STAFF REPORT

Planning and Zoning: 5/4/2015 **Staff Contact:** Erin Sellers, Planner II
Agenda Item: 2015-3824 **E-mail:** erins@pflugervilletx.gov
Case No. ARB1503-01 **Phone:** 512-990-6300

SUBJECT: Consider an architectural waiver to the commercial building design requirements for an expansion to the Private Warehouse Mini-Storage facility, locally addressed as 612 F.M. 685.

Northern Buildings

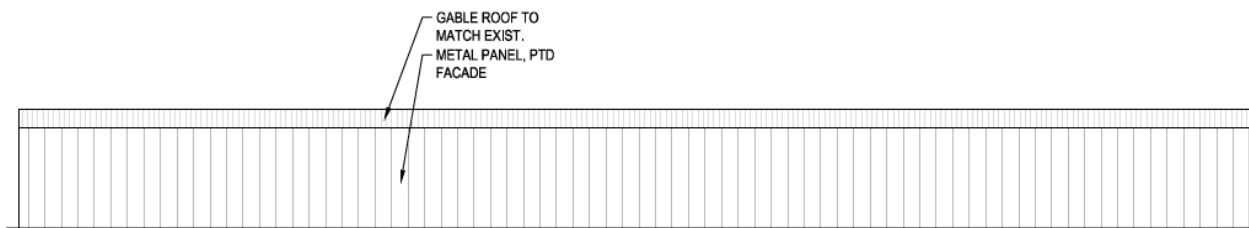
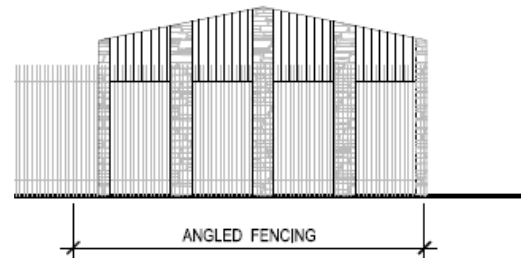
The Applicant has proposed two mini-storage buildings on the north side of the property comprised of metal panels on all facades, with the exception of the façade fronting F.M. 685 where 52% is stone excluding doors.

2. Two mini-storage buildings on the north side of the property may be comprised of metal panels on all facades, with the exception of the Northeastern building's façade fronting F.M. 685 where 52% is stone excluding doors. All other facades may be metal paneling consistent with the existing buildings.
3. The proposed buildings would not need to include additional horizontal and vertical articulation beyond what is shown on building elevations provided.
4. The architectural waiver shall automatically expire within 24 months from the date of approval if a site development permit has not been secured for the development. If a site development permit has been approved, the architectural waiver will remain valid until such time the site plan has expired.

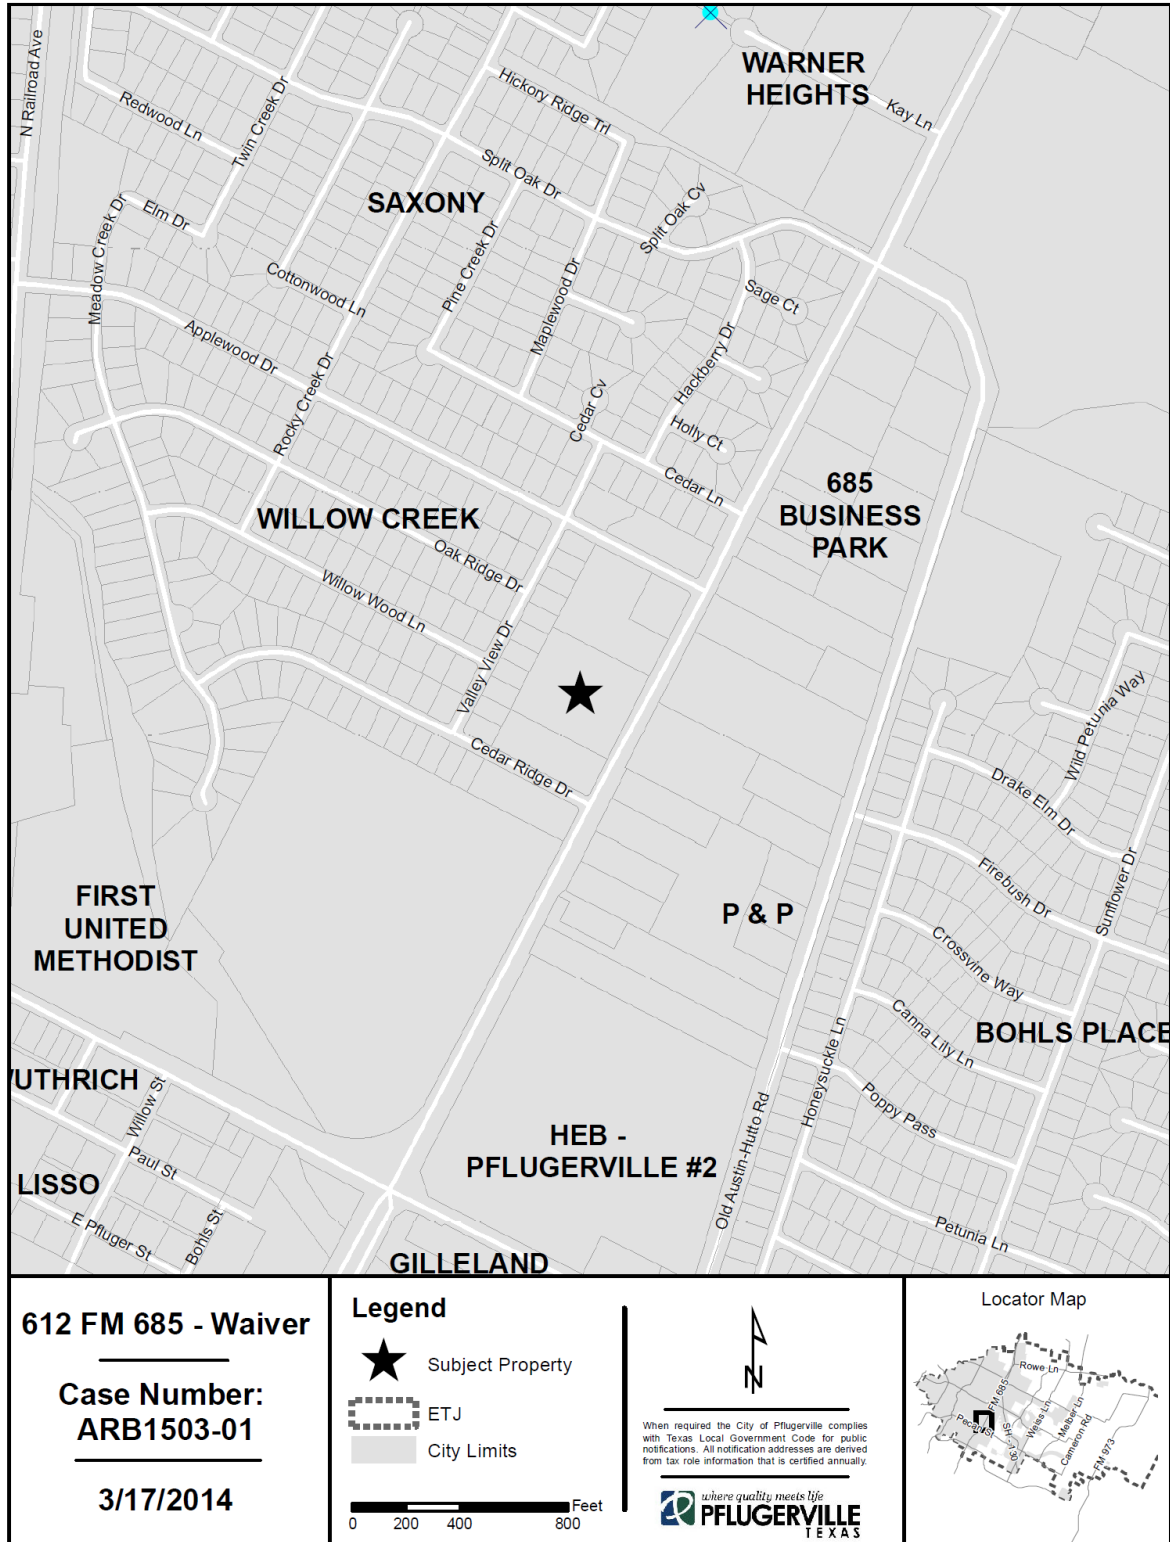
1. The Eastern Building Fronting F.M. 685 shall be comprised of the following materials.

Table 1: Eastern Building Fronting F.M. 685	
East Façade (150 linear feet fronting F.M. 685)	100% Stone (1300 S.F.);
North	52% Stone (42 S.F.), 48% Metal Panels (39 S.F.)
South	52% Stone (42 S.F.), 48% Metal Panels (39 S.F.)
West Façade (Internal wall with Overhead doors)	100% Metal Panels (578 S.F.)
Total Facades (Excluding doors)	68% Stone; 32% Metal Panels (excluding doors)
